TI_2126: New additional I/O board A13 for movement management

iVario 2-XS / iVario Pro

28/09/2021

Structure of the A13 I/O board:

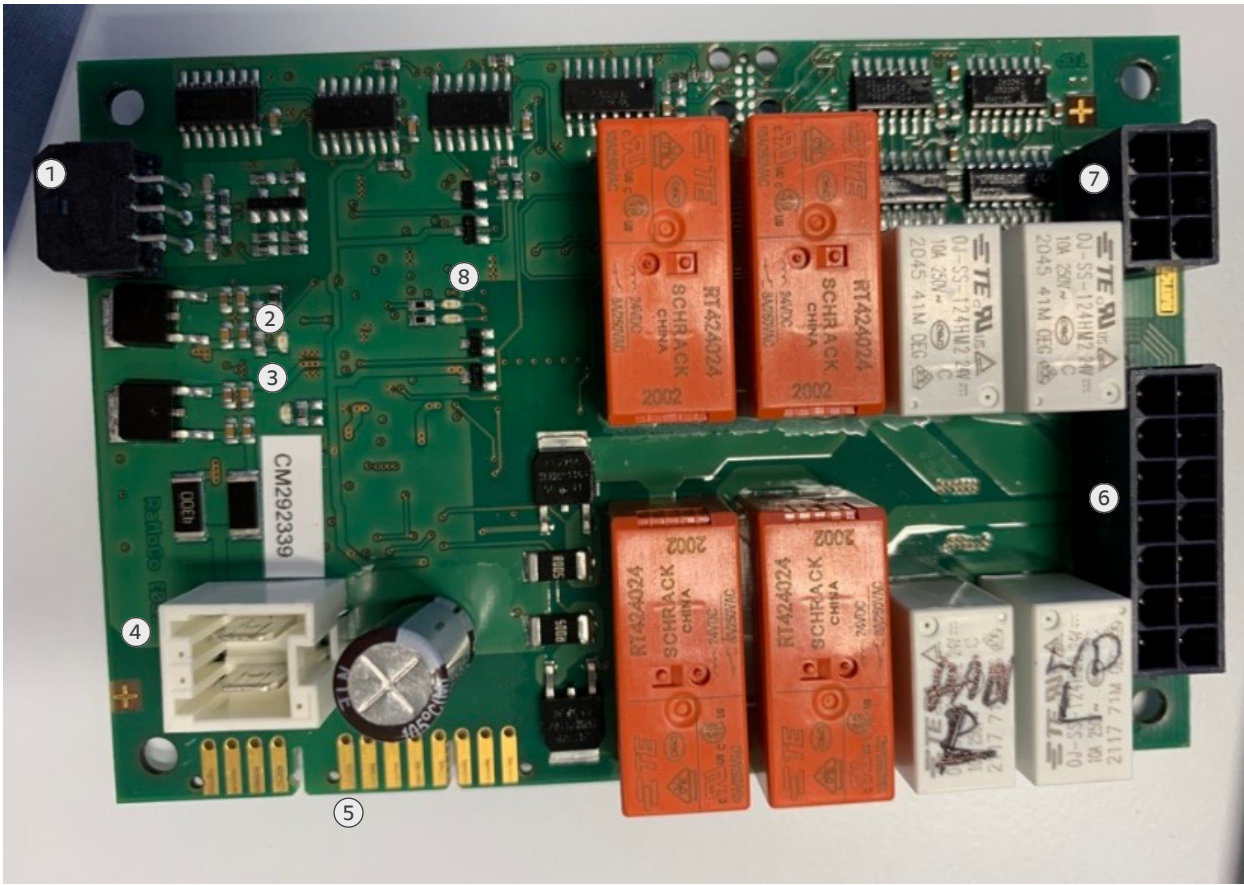
1	X1 BUS connection to the A10 I/O board
2	LED: 3.3V OK (control unit)
3	LED: 5V OK (PT1/PT2)
4	X5: 24V power supply (T5)
5	X4 / 142: Drain valve and lid lock system power supply and return
6	X3: Power supply for pan and lid motor
7	X141: Return of the pan and lid motor
8	LED flashes: Green / red Communication: OK / not OK

iVario 2-XS and 2-S

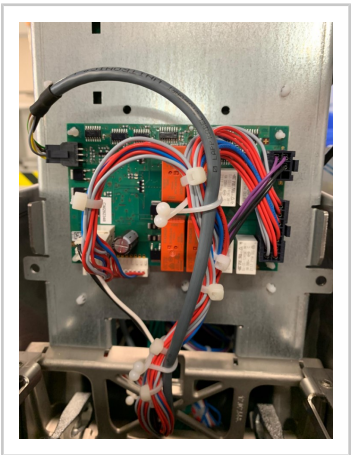
A13 I/O board is installed behind the A10 board

iVario L and XL

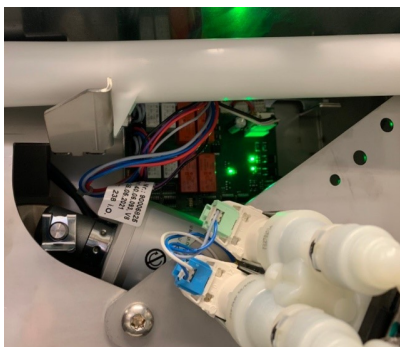
The A13 I/O board is installed below the A10 I/O board behind the solenoid valves.

Hardware changes

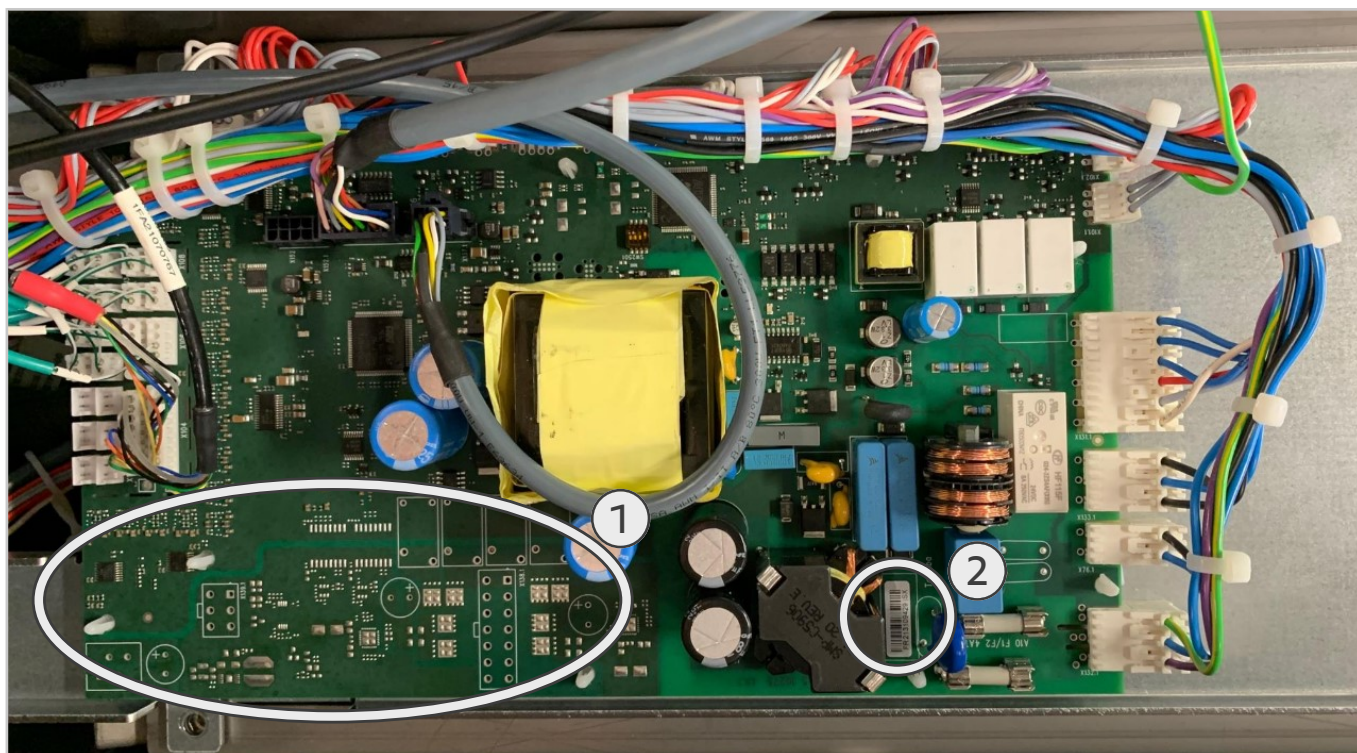
Because the movement management was removed from the original I/O board (A10), a new hardware version has been created: Hardware version 5. The serial numbers of these boards without movement management end with "SX".

| 1 | Missing movement components |
| 2 | Serial number ending "SX" |

Software changes

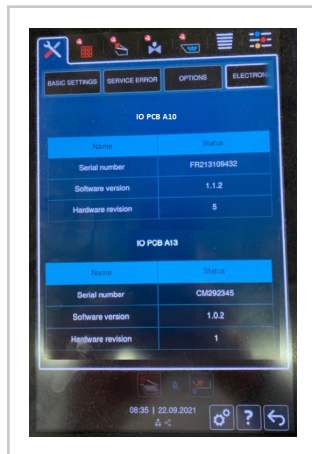
The software automatically checks whether the movement is controlled by A10 (hardware version 1 or 4 of A10) or by A13 (hardware version 5 of A10, serial number ends with SX). Details on I/O boards can be found on the service level under General/Electronics.
